## SYDNEY CENTRAL CITY PLANNING PANEL

### COUNCIL ASSESSMENT REPORT

<b>Panel Reference</b>	2017SWC104
<b>DA Number</b>	DA/754/2017
<b>LGA</b>	City of Parramatta
<b>Proposed Development</b>	Demolition of three buildings on site; removal of 8 trees, removal of one portable building; construction of a three storey building comprising an educational establishment with a library, learning rooms and amenities, alterations and change of use of rooms within existing building A. The proposed number of students will be increased to 736 (from 414).
<b>Street Address</b>	27-33 Pembroke Street, Epping
<b>Applicant</b>	TSA Management – Ian Guthrie
<b>Owner</b>	NSW Department of Education
<b>Date of DA lodgement</b>	1 September 2017
<b>Number of Submissions</b>	5 Submissions
<b>Recommendation</b>	Approval subject to conditions
<b>Regional Development Criteria (Schedule 4A of the EP&amp;A Act)</b>	Pursuant to Clause 5 of Schedule 4A of the Environmental Planning and Assessment Act 1979, Crown development that has a capital investment value of more than \$5 million.

## **SECTION 4.15 ASSESSMENT REPORT – EDUCATIONAL ESTABLISHMENT**

Figure 7 – Clause 4.6 Height Variation

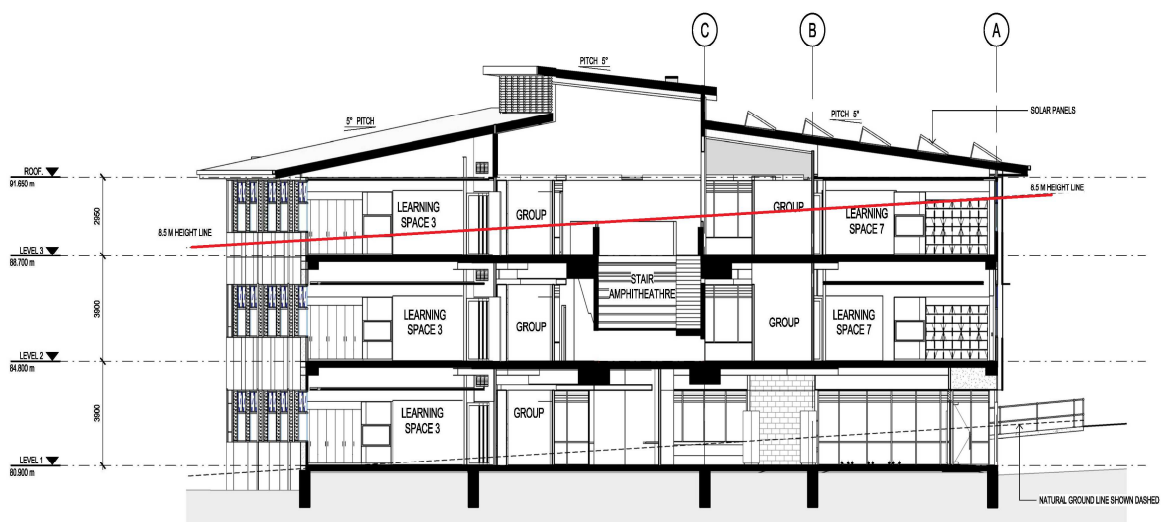
A request for an exception under Clause 4.6 was lodged with the application as the proposed development exceeds the maximum height for the site permitted by Clause 4.3 of HLEP 2013. The variation sought is as follows:

- *The development proposal will align with the desired future character of the area;*
- *The proposed built form relates to the context in terms of scale and topography, with the upper levels being recessed from the building edge to downplay visual dominance, ensuring that the visual impact of the encroachment is minimised;*
- *The development proposal is consistent with the intent of the maximum height control and will provide an attractive building that will address both Pembroke Street and Norfolk Road;*

The non-compliance is considered to be acceptable. A variation of up to 42% (6m) in height is proposed to accommodate the third floor of the educational establishment. The building is sited on the corner of Pembroke Street and Norfolk Road. The shadow diagrams illustrate that the proposed building will not cast shadows over any surrounding residential properties and therefore will not unduly diminish solar access.

That the Clause 4.6 exception to the development standards of Clause 4.3 Height of Buildings in the Hornsby LEP 2013, is considered to be well founded and worthy of support.
